UTAH DEPARTMENT OF TRANSPORTATION

SUBJECT: Standards Committee Meeting Minutes and Next Meeting

Specification/Drawing/Item Title: Pre-cast Constant Slope Concrete Barrier

Specification/Drawing Number: 02844 / New BA 03C drawing

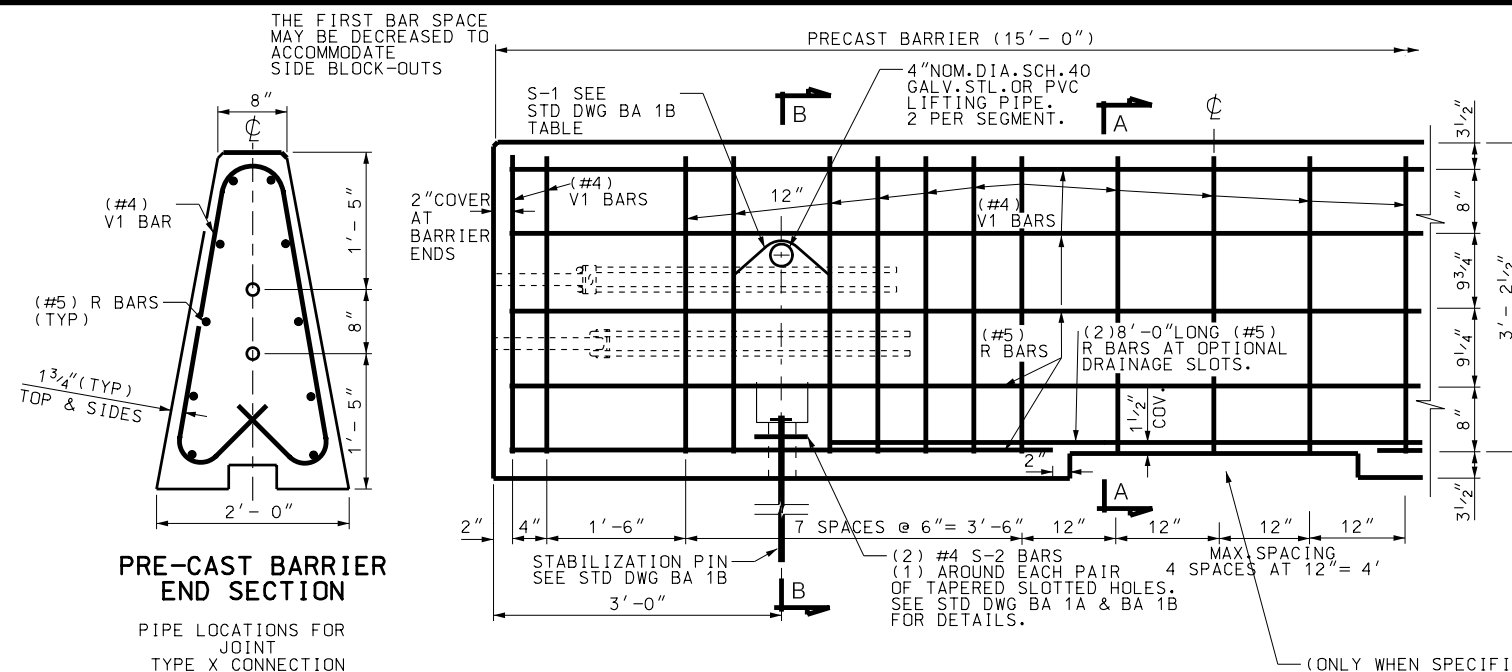
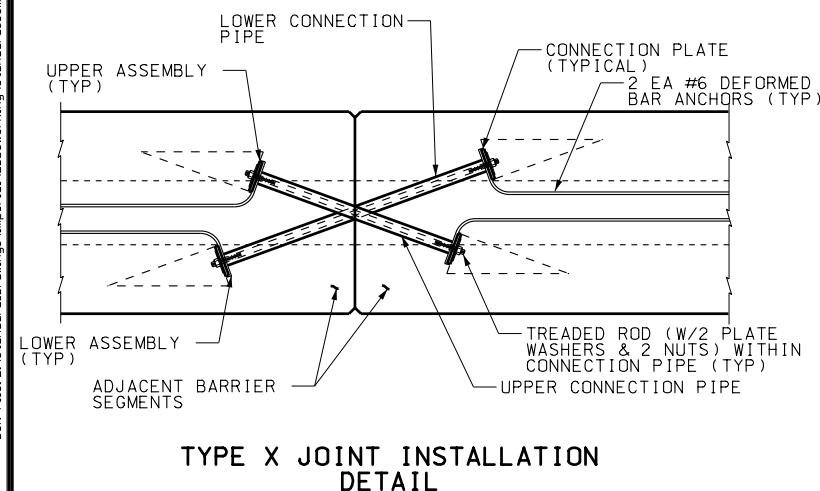
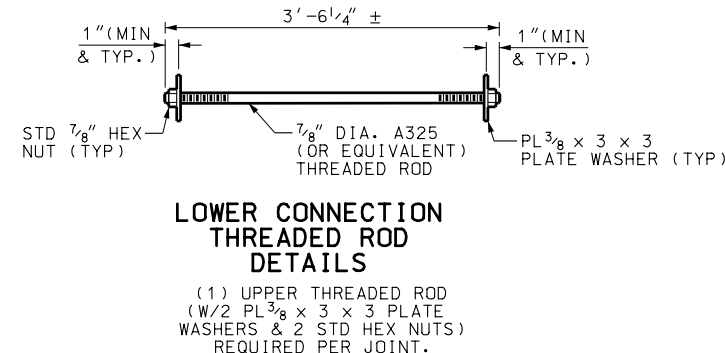
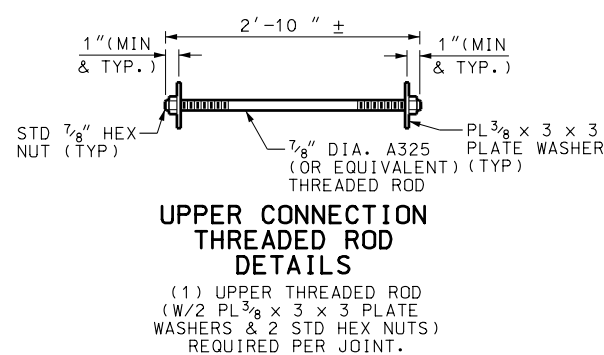
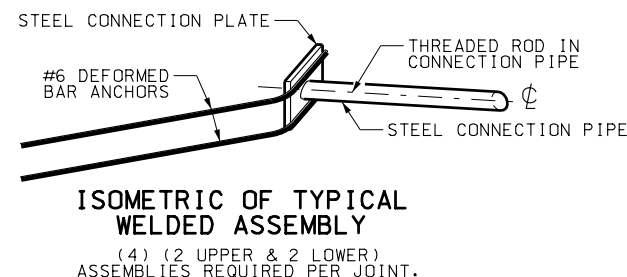
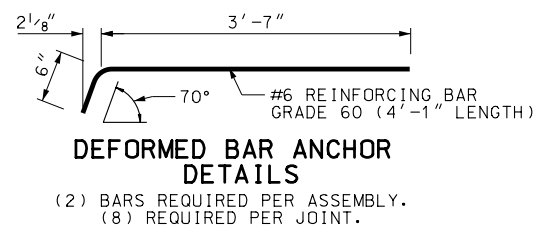
1. Upper Connection Threaded Rod Details: Correct spelling of "Details"; Revise Dia. of A325 Rod to 7/8" to match nut.
2. Lower Connection Threaded Rod Details: Revise "Upper" to "Lower"; Revise Dia. of A325 Rod to 7/8" to match nut.

3. Connection Details: Place space between "After" and "Fabrication".
4. Reinforcement for Precast Constant Slope Concrete Barrier (Type 1): Clarify 30'-0" \pm 1" dimension. Should it be 30'-0" \pm 1"?

5. Barrier Plan At Joint: Add (Typ) to bottom orthogonal Leave-Out dimensions; "Block-Out" is the commonly used term for "Leave-Out".
6. Deformed Bar Anchor Details: Use 3'-7" length instead of 3'-3" to fully develop bar strength per AASHTO requirements.

Add (Only when specified) for drainage slot

Add note for barrier seal between sections

Add Barrier marking requirements

Add pad requirements
